**ADDENDUM NO. 3
NEW ELEVATOR
AT MURPHY ELEMENTARY SCHOOL
ROUND LAKE SCHOOL DISTRICT NO. 116
PROJECT NO. 23170**

Board of Education
Round Lake School District 116
884 West Nippersink Road
Round Lake, Illinois 60073

This Addendum shall be part of the Specifications & Requirements for this project and shall be part of the actual contract document to complete the work. There are four (4) items in this Addendum.

2 PARTIAL FIRST FLOOR ELECTRICAL PLAN
 1/4" = 1'-0"

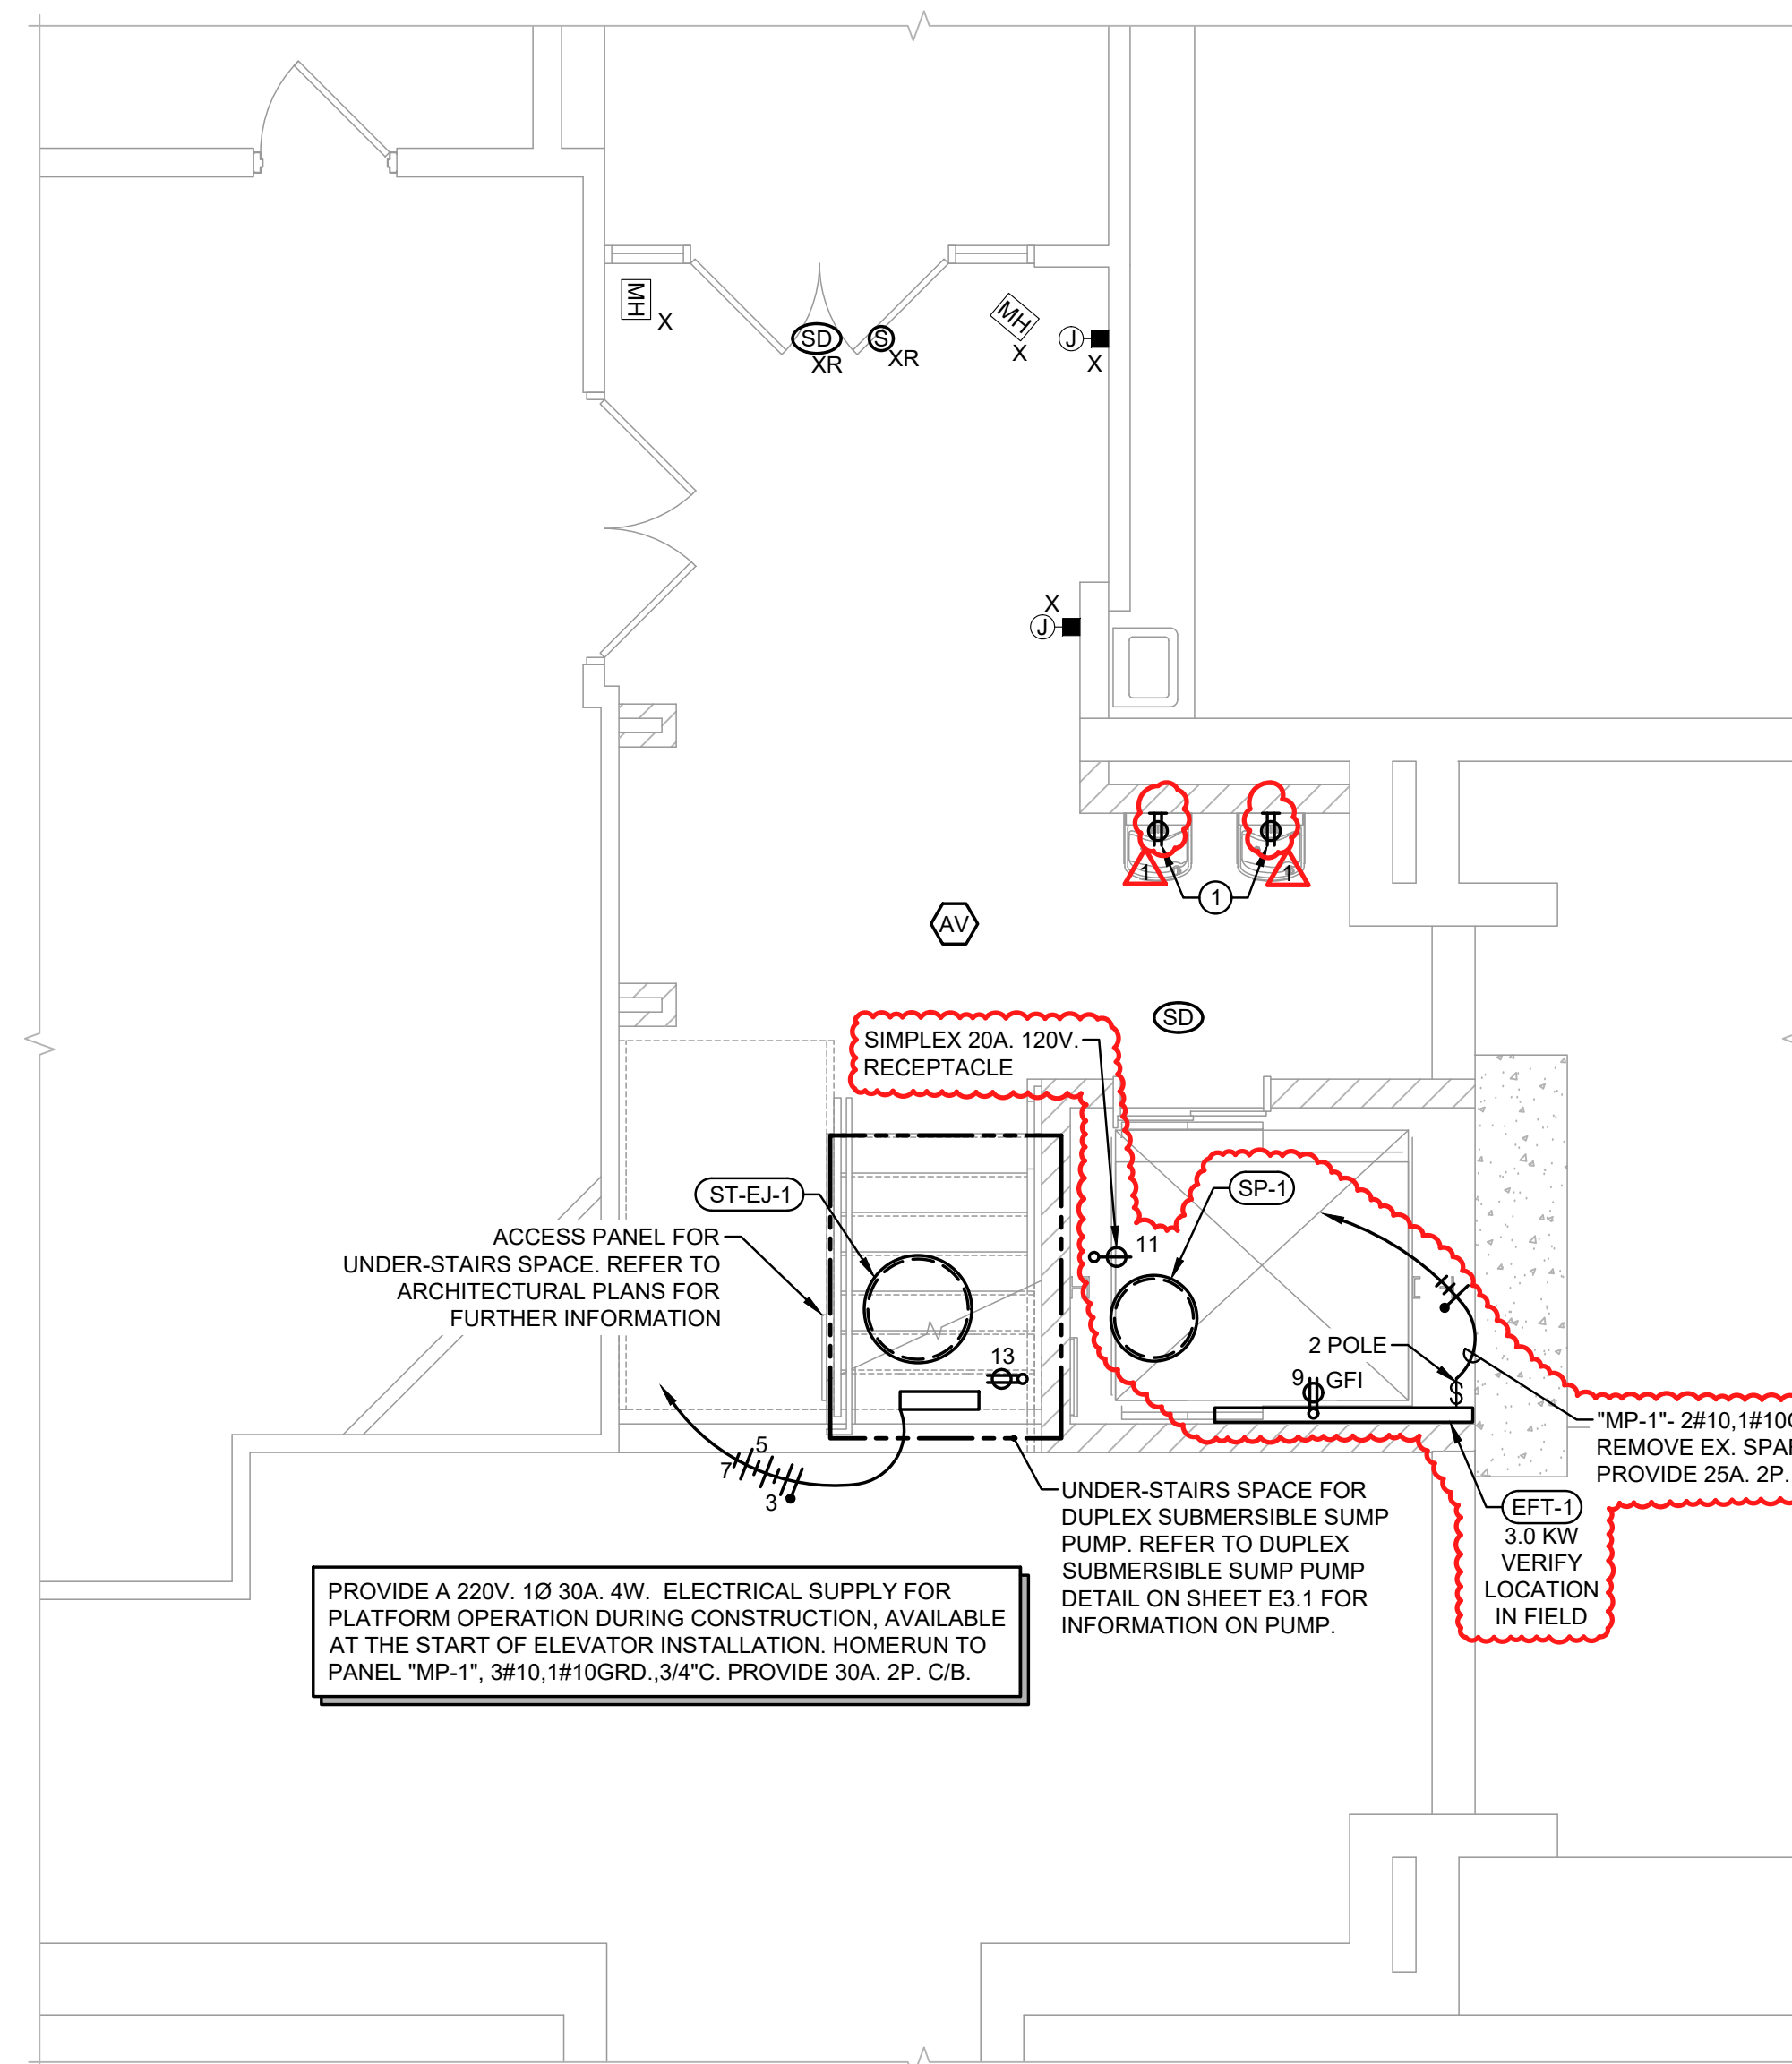
ITEM NO. 4: DRAWINGS, SHEET E1.1, PARTIAL ELECTRICAL PLANS

1. Add electric strike, two (2) door contacts, and exterior card reader for exterior door on Partial First Floor Electrical Plan.
2. Add note to drawing to say "EC to provide rough-ins for access control devices. EC to sub-contract devices and wiring to NTI"
3. Add phone connection to elevator in Partial Upper Floor Electrical Plan with note to say "Dedicated POTS or digital POTS connection. Verify connection type with elevator manufacturer and owner. Verify Exact location prior to rough-in."
4. Move submersible pump "SP-1", Electric Finned Tube "EFT-1", 2 pole disconnect switch, duplex GFCI type receptacle, and simplex receptacle from the First Floor Electrical Plan to the Lower Floor Electrical Plan.
5. Refer to attached drawing E1.1 and refer to highlighted items for updates.

- DEDICATED POTS OR DIGITAL POTS CONNECTION. VERIFY CONNECTION TYPE WITH ELEVATOR MANUFACTURER AND OWNER. VERIFY EXACT LOCATION PRIOR TO ROUGH-IN.

EC TO PROVIDE ROUGH-INS FOR ACCESS CONTROL DEVICES. EC TO SUB-CONTRACT DEVICES AND WIRING TO NTI.
